ARKANSAS NUCLEAR ONE - UNIT 1

IMPROVED TECHNICAL SPECIFICATIONS SUBMITTAL

VOLUME 1 OF 7

January 28, 2000

Figure 2.1.1-1 (page 1 of 1)
Reactor Coolant System Departure from Nucleate Boiling Safety Limits

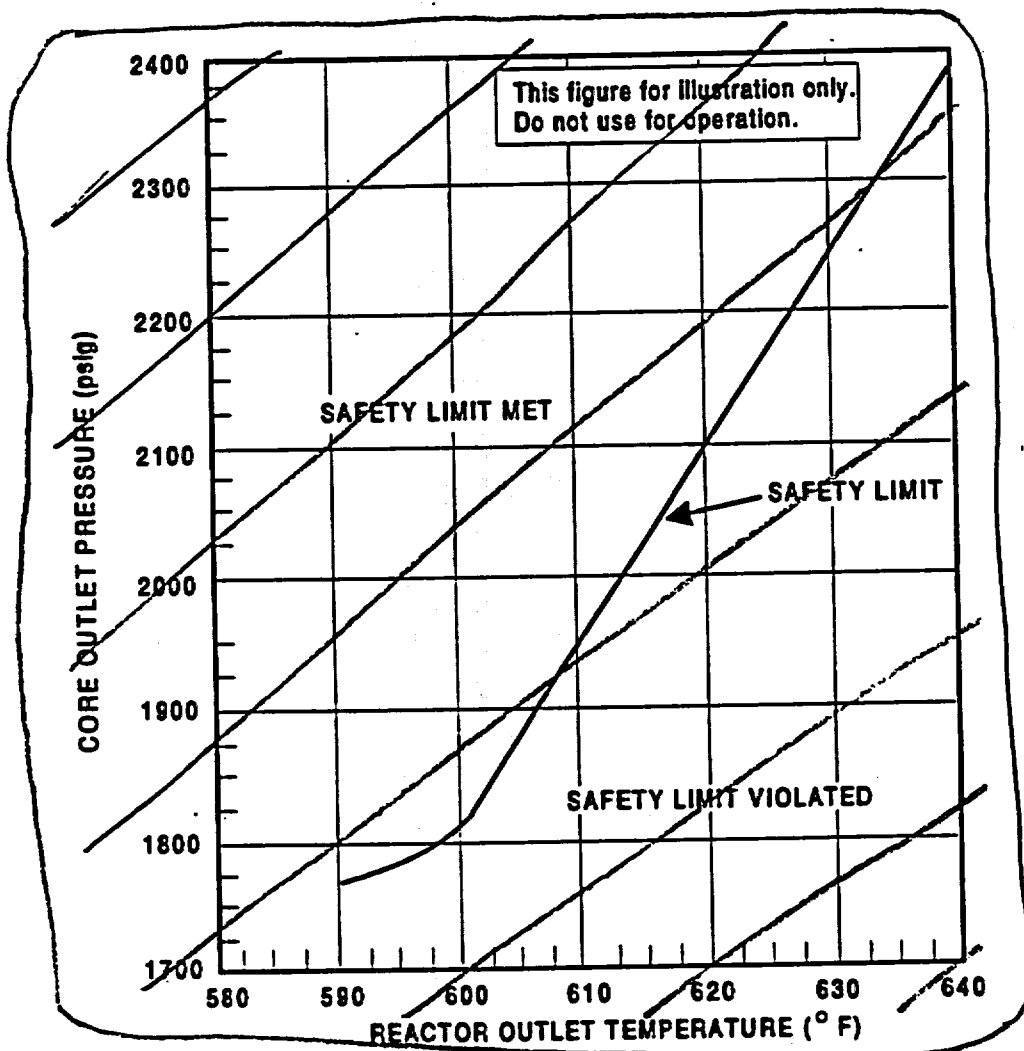
~~2.2.8 Operation of the plant shall not be resumed until authorized by the NRC.~~

③

Figure 2.1.1-1 (page 1 of 1)
Reactor Coolant System Departure from Nucleate Boiling Safety Limits

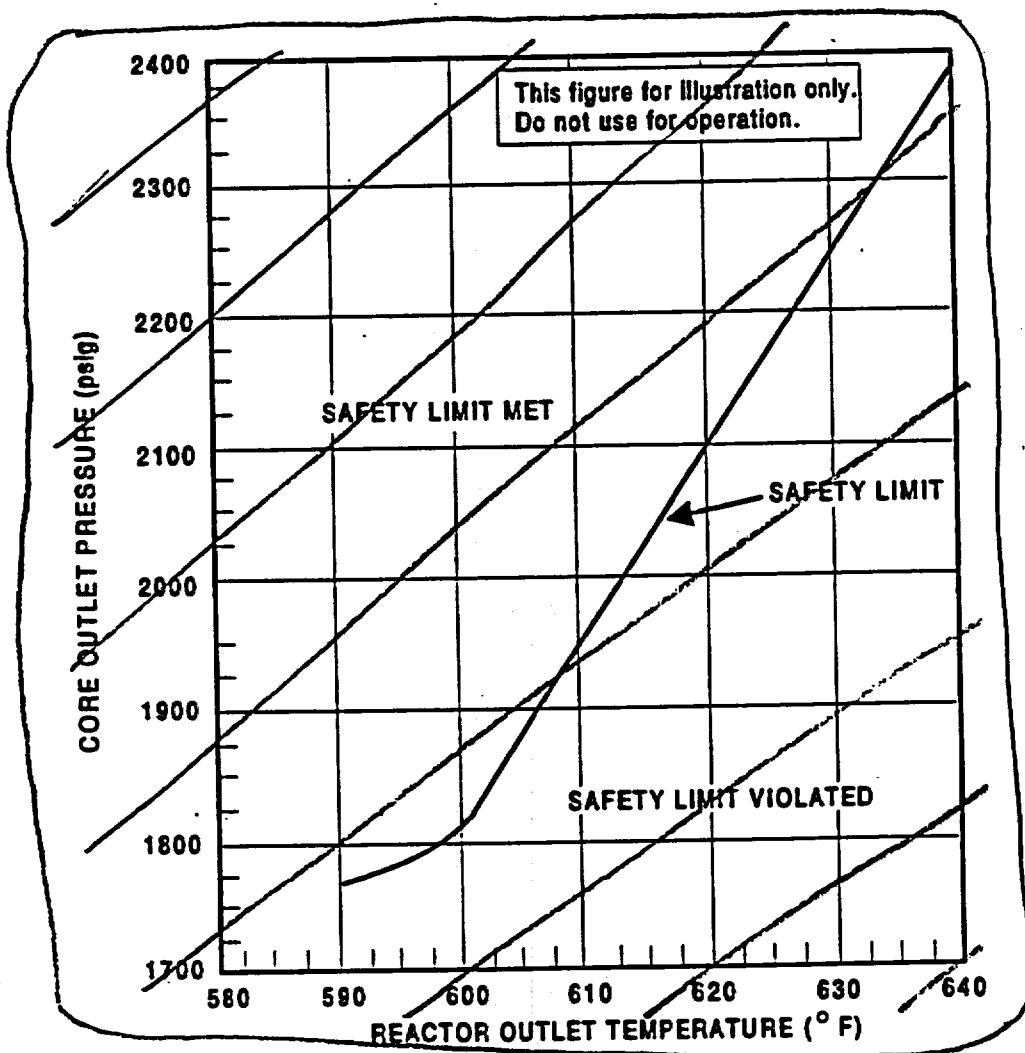
~~2.2.8 Operation of the plant shall not be resumed until authorized by the NRC.~~

(3)

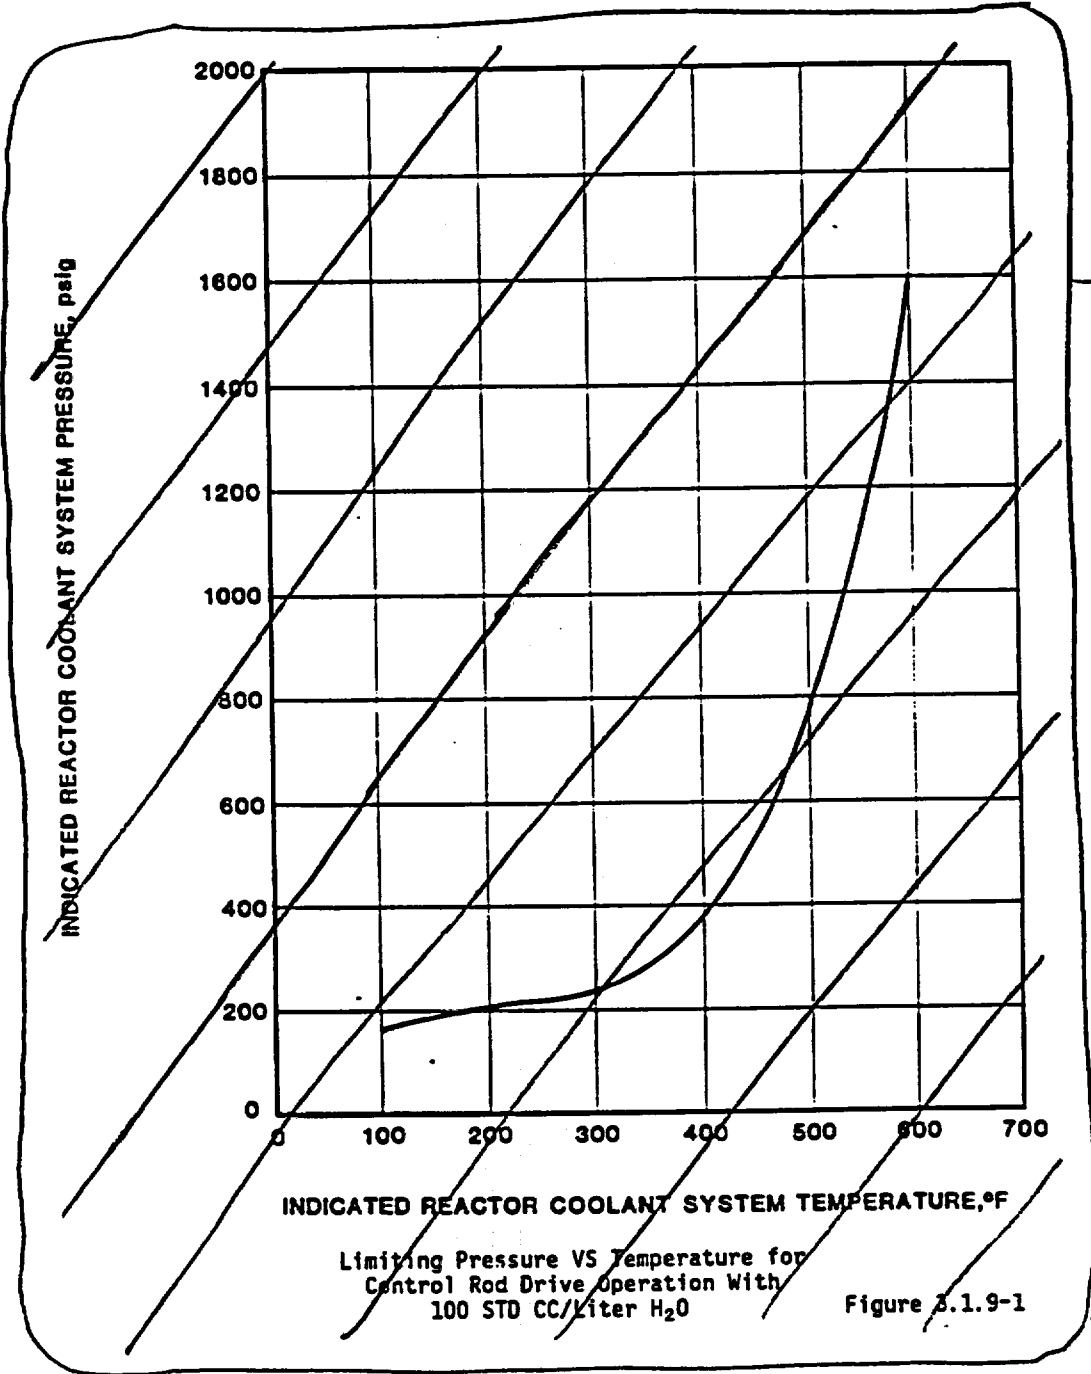
- 3.1.9.1 The concentration of dissolved gases in the reactor coolant shall be limited to 100 std. cc/liter of water at the reactor vessel outlet temperature.
- 3.1.9.2 Allowable combinations of pressure and temperature for control rod operation shall be to the left of and above the limiting pressure versus temperature curve for a dissolved gas concentration of 100 std. cc/liter of water as shown in Figure 3.1.9-1.
- 3.1.9.3 In the event the limits of Specifications 3.1.9.1 or 3.1.9.2 are exceeded, the vessel level instrument vent shall be checked for accumulation of undissolved gases. The temperature, pressure, and dissolved gas concentration shall be restored to within their limit within 24 hours or be in at least HOT STANDBY within the next 6 hours and in COLD SHUTDOWN within the following 30 hours.

L14
